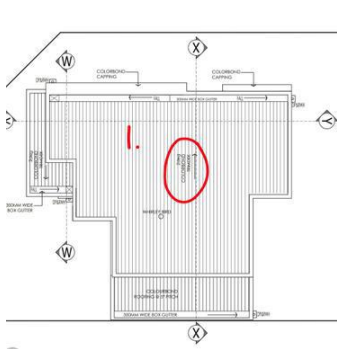
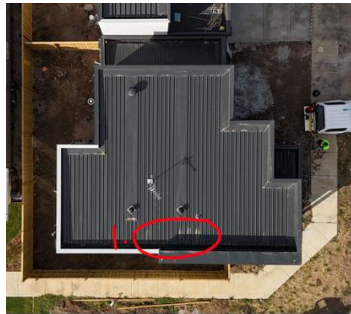
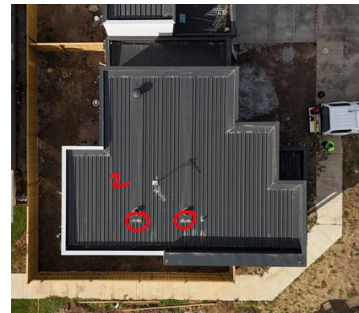
- 1. Roof pitch not achieved as per approved plans. Roof sheets are damaged/creased causing ponding on the roof sheets.
- 2. Flashings not free draining as screws have flattened the flashing.

Refer to AS 3500.3: Plumbing and drainage Part 3: Stormwater drainage section 4.4.3 Corrosion due to crevices:

"Metal roof drainage systems and support systems shall be designed and installed to achieve complete drainage or drying. Shielded areas capable of causing permanent ponding shall be avoided to prevent the possibility of intense localized corrosion known as crevice corrosion.

2.4.2: Windows sealed

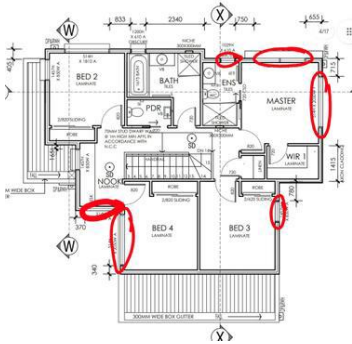
Numerous gaps to all windows, all to be reviewed

Windows not sealed.

2.4.1: Visible leaks in roofing, flashings and accessories

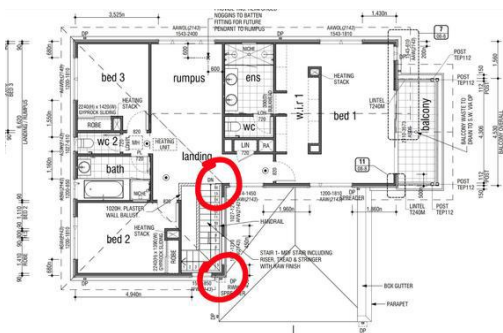
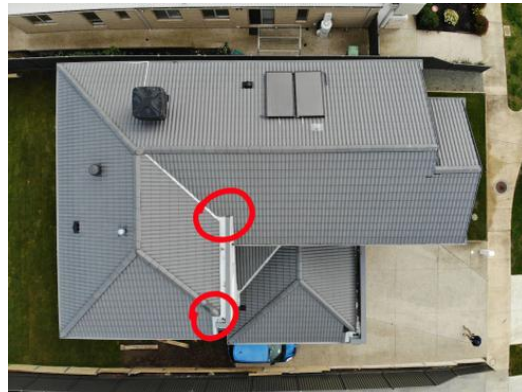
Overflashings not installed X2 where soaker tray upstands penetrate through the roof tiles.

The Building Code of Australia Volume 2, Performance Requirement P2.2.2 Weatherproofing: "A roof and external wall (including openings around windows and doors) must prevent the penetration of water that could cause—
(a) unhealthy or dangerous conditions, or loss of amenity for occupants; and
(b) undue dampness or deterioration of building elements."

Other item 2.4.3. 4

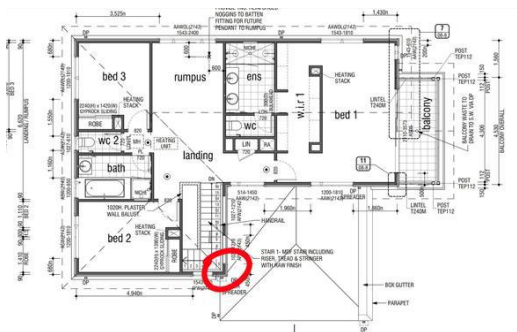
Parapet capping minimum cover of 50mm not achieved and capping is gapped to wall allowing rainwater to enter.

Refer to Australian Standard HB39 Installation code for metal roof and wall cladding 8.1.4 Sizes and covers:

"The minimum cover over other materials and structures for roof flashings and cappings is given in Table 8.1.4. For jointing, see Clause 5.8."

"A roof and external wall (including openings around windows and doors) must prevent the penetration of water that could cause— (a) unhealthy or dangerous conditions, or loss of amenity for occupants; and (b) undue dampness or deterioration of building elements."
